UNITED STATES EPARTMENT OF THE I UREAU OF LAND MANA	NTERIOR OCD	Artosia O	FORM APPROVED MB NO. 1004-0137 pires: January 31, 2018	
SUNDRY	SUNDRY NOTICES AND REPORTS ON WELLS Do not use this form for proposals to drill or to re-enter an		5. Lease Serial NMLC028		
abandoned well. Use form 3160-3 (APD) for such proposals.		6. If Indian, All	lottee or Tribe Name		
SUBMIT IN TRIPLICATE - Other instructions on page 2 1. Type of Well Oil Well Gas Well Other			7. lf Unit or CA 89101239	 If Unit or CA/Agreement, Name and/or 8910123980 Well Name and No. RJ UNIT 127

RJ Unit # 127 WBD (2)

Permanent Abandonment of Federal Wells Conditions of Approval

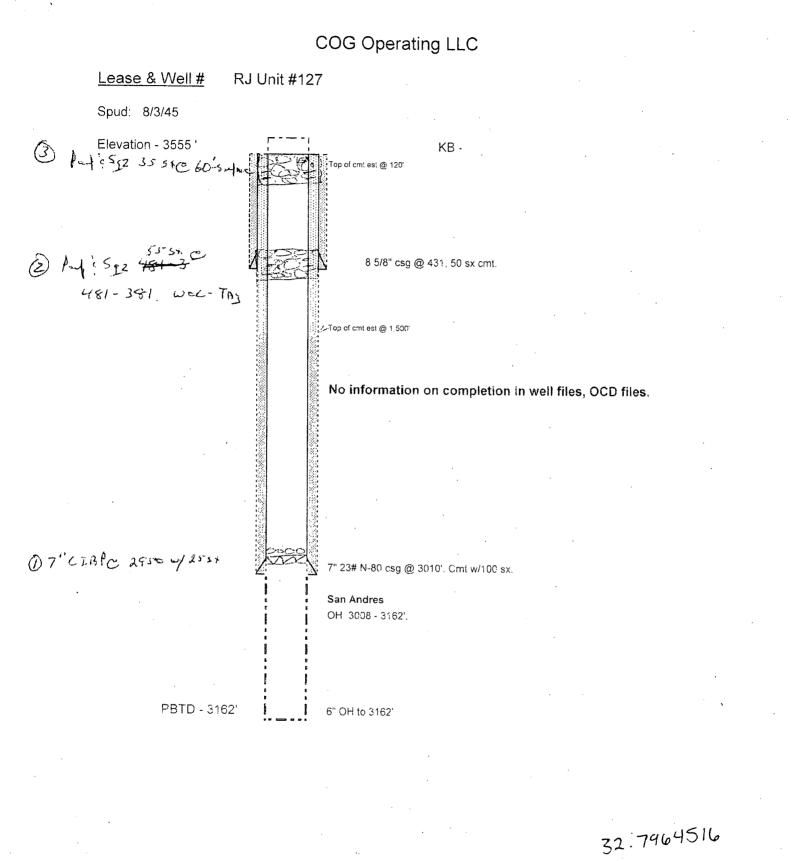
1. Set 7" CIBP @ 2950'. Spot MLF. ALA • • • • • • • • • 2. Perf & Sqz 55 sx @ 481 38 3. Perf & Sqz 35 sx @ 60' to s	25 sx cmt on top. Pressu 4 (a) 840. SQ Z 4 WOC & Tag. 3 D 7 surface.	re test csg, to 500 psi. Circula - cm+ to 740. C Shoe & T/Sal	te hole w/ 2485 . -762

1. Set 7" CIBP @ 2950". Spot MLF. Add Order 2. Perf & Sqz 55 sx @ 481 30 3. Perf & Sqz 35 sx @ 60' to s 4. Cut off wellhead and weld o	25 sx cmt on top. Pressu 4 3 840. So z 4 WOC & Tag. 3 0 7 surface. on Below-Ground Dry Hole G C 8/ Accepted for reco	te test csg. to 500 psi. Circula Cont to 740. Cont to 740. Shoe E 7/Sol Marker. SEE CON 463658 verified by the BLM Wel PERATING LLC, sent to the Ca	te hole w/ 2485. (B) ATTACHED F(NDITIONS OF A	Cnt to 220 (salt) OR PPROVAL RECEMED AUG 21 201
